Request for Continued Examination (RCE) Transmittal

Application Number	10/798,693
Filing Date	03/11/2004
First Named Inventor	Stanton
Art Unit	3673
Examiner Name	LEE
Attorney Docket Number	CLPS-18789

RESPONSE TO OFFICE ACTION DATED JUNE 10, 2009

FIG. 6

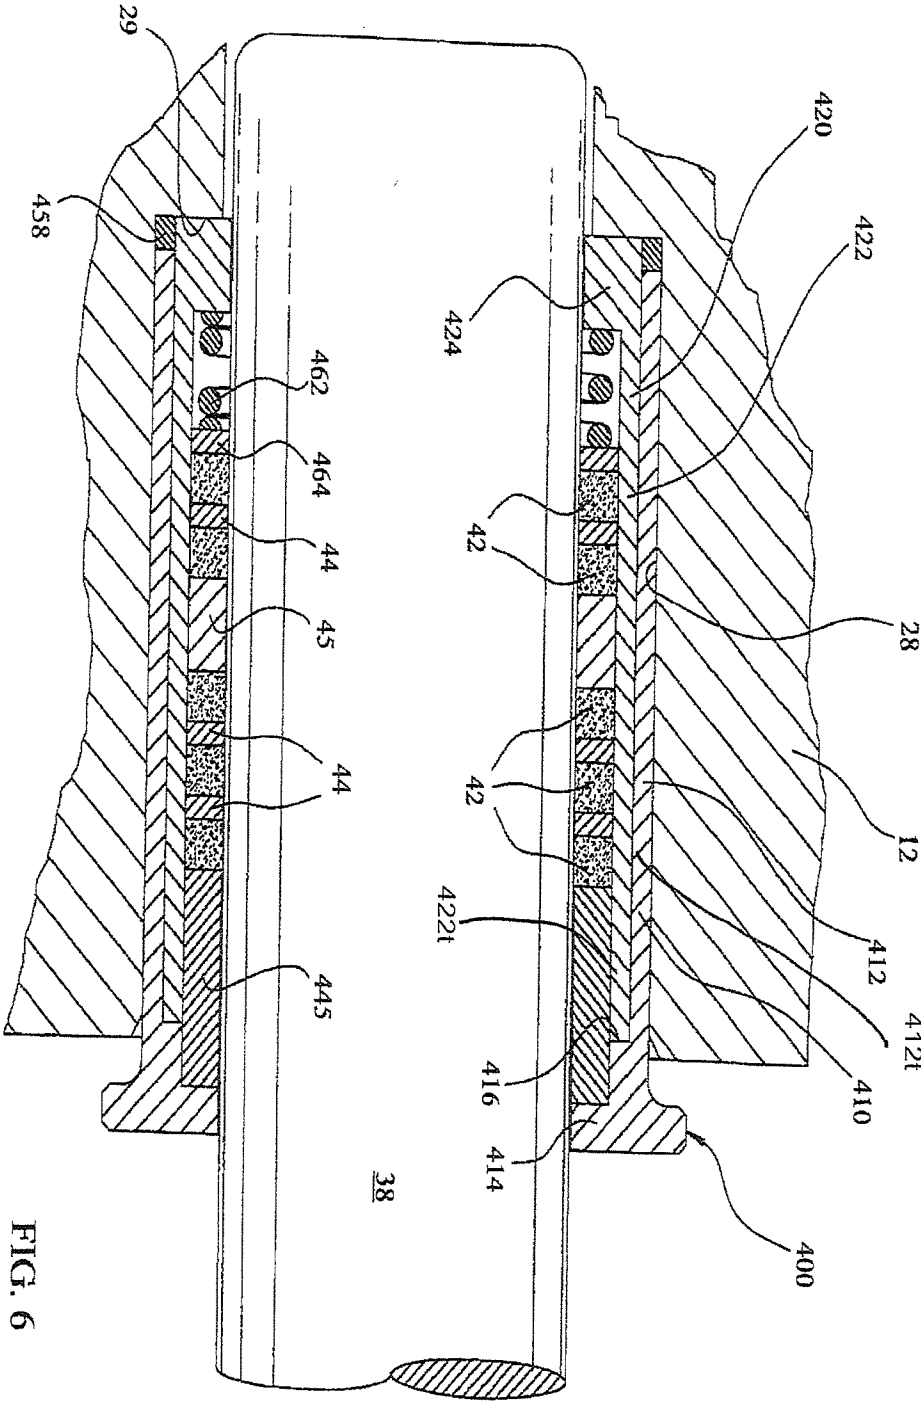
Regarding Figures 6 and 12, Paragraphs 0156 and 0158 of the specification are amended to include the specific references 412t and 422t for the “telescoping structures” and Figures 6 and 12 of the drawing is amended to include these references. Figure 12 is a cross-sectional view of another embodiment of a packing cartridge similar to the embodiment shown in Figure 7 (*See, e.g.*, Specification Paragraphs 0076 and 0193), where Figure 7 is a cross-sectional view of another embodiment of a packing cartridge similar to the embodiment shown in Figure 6 (*See, e.g.*, Specification Paragraphs 0068 and

[0156] Preferably, a spacer ring **445** is positioned operatively to cover the overlapping travel of the telescoping structures 422t and 412t between the first and second sleeve portions **410** and **420**. This spacer ring **445** helps prevent seepage of fluid into any clearances between the first sleeve portion **410** and the second sleeve portion **420**. The spacer ring **445** can also act as a back-up ring for the packing rings **42**.

[0158] As will be appreciated, the telescoping structures 422t and 412t of the first sleeve portion **412** and the second sleeve portion **422** allow for squeezing of the first abutment ring **414** and the second abutment ring **424** co-axially closer to one another after positioning the pre-assembled packing cartridge **400** on a plunger **38** in the packing bore **28**. However, in this embodiment, the packing cartridge **400** is positioned in the packing bore **28** and tightened by a gland nut (not shown) until the second sleeve portion **422** bottoms out against a shoulder **416** of the first sleeve portion **412**. In this position, the coil spring **462** is compressed with a packing assembly positioned between the first abutment ring **414** and a second abutment ring **424**. The advantage of bottoming out the telescoping structures 422t and 412t is that it prevents over-tightening of the packing cartridge **400** in the packing bore **28**. The spring **462** maintains a pre-determined amount of axial compression on the packing rings **42** of the packing stack.
